**RESOLUTION HOLDING HEARING REGARDING REQUEST FROM HUBBELL REALTY COMPANY (OWNER), REPRESENTED BY CALEB SMITH (OFFICER), FOR REVIEW AND APPROVAL OF A 1<sup>ST</sup> AMENDMENT TO THE GRAY’S STATION PUD CONCEPTUAL PLAN, FOR PROPERTY LOCATED IN THE VICINITY OF 1300 TUTTLE STREET, TO UPDATE THE REALIGNMENT OF SOUTHWEST 13<sup>TH</sup> STREET AND TO REVISE REVIEW REQUIREMENTS FOR FUTURE PUD DEVELOPMENT SITE PLANS**

# CONCEPTUAL PLAN, FIRST AMENDMENT GRAY'S STATION

# SITE DEVELOPMENT PLAN FOR: GRAY'S STATION TELUS

# GRAY'S STATION PLAT 5

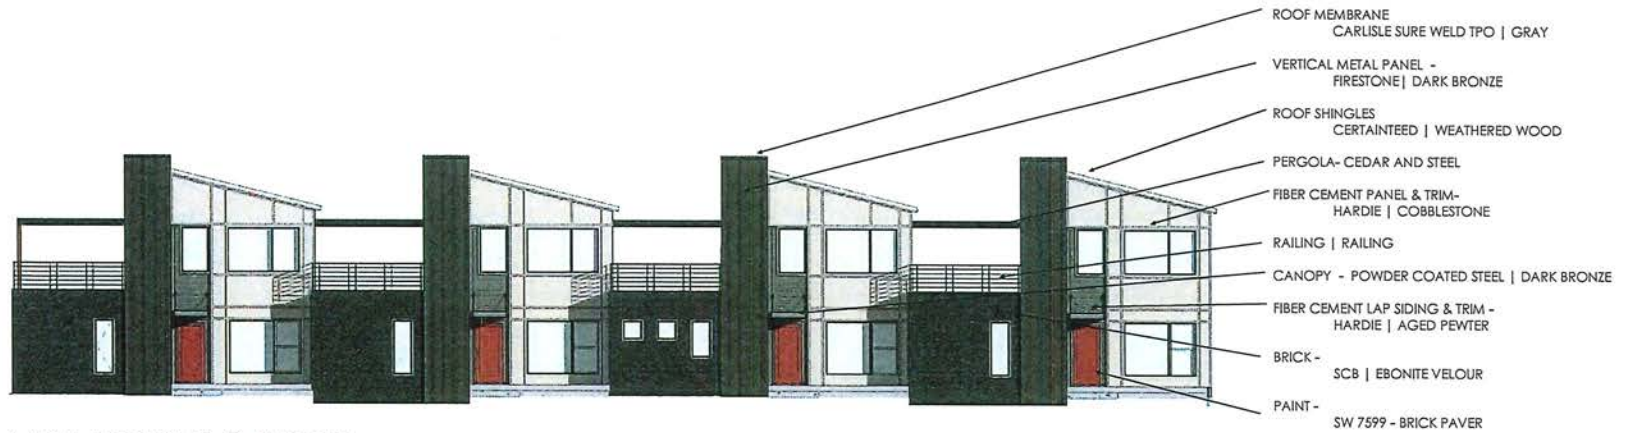
The desire was to create a darker color package for this Product and add some variation between the units.

- Increased visual interest through varying heights of the entry element clad in metal panels.
- Revised the color scheme and made it darker to achieve a more urban look.

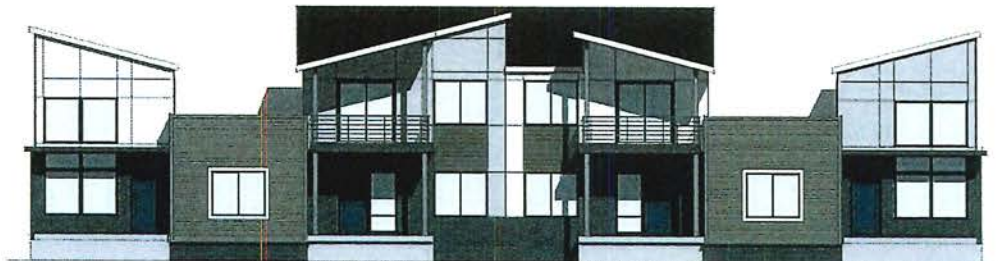
This elevation was too busy and the color scheme too light for this urban environment.

- Changed to a darker color scheme to achieve a more urban look.
- Changed Hardie lap siding on front to metal panels.
- Eliminated the white-colored Hardie panels and matched the panel color on both sides to achieve a unified appearance.
- Steel metal posts will be painted dark gray.

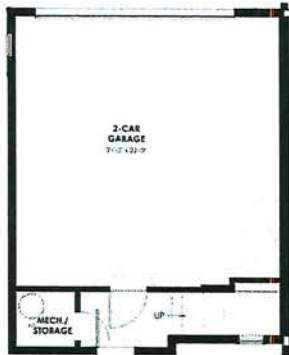
Elevation appeared boring and repetitive. These needed additional visual interest and a more urban look.

- Varied the height of the brick/stone to create diverse building elements and to reduce the repetitive effect of the vertical building elements.
- Introduced building elements sided in metal panels with a vertical pattern.
- Replaced the Hardie panels of one or more of the main building elements with metal panels (horizontal pattern).
- Black windows
- Darkened the color packages
